# UNITED STATES PATENT AND TRADEMARK OFFICE

APPLICATION NO.	FILING DATE	FIRST NAMED INVENTOR	ATTORNEY DOCKET NO.	CONFIRMATION NO.
09/538,754	03/30/2000	Michael Alexandrovich	Alexandrovich 1-12-9	8954

## Office Action Summary

## **DETAILED ACTION**

*FIG. 3C*

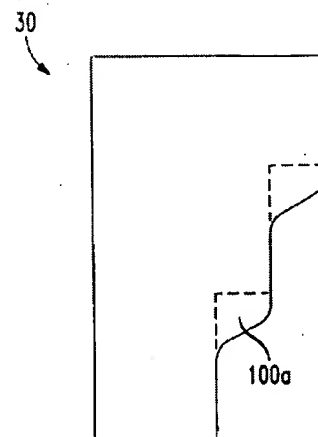
Rinaudo et al ("Rinaudo" hereinafter) show a controlled multi-wavelength etalon comprising:

a first planar reflecting surface;

a second planar reflecting surface positioned parallel to and at a first distance from the first planar reflecting surface;

a third planar reflecting surface positioned parallel to and at a second distance from the first planar reflecting surface, the second distance being greater than the first distance, the second planar reflecting surface having a first edge and the third planar reflecting surface having a second edge, the first and second edges facing one another; and

a step having a sloping planar surface adjoining the first and second edges.

With regards to claim 2, the step is positioned such that a portion of a light passing through the first planar reflecting surface impinges on the sloping planar surface at an angle such that it passes through the sloping planar surface.

With regards to claims 5, 6, 14, and 15, the surfaces are formed on glass or silicon.
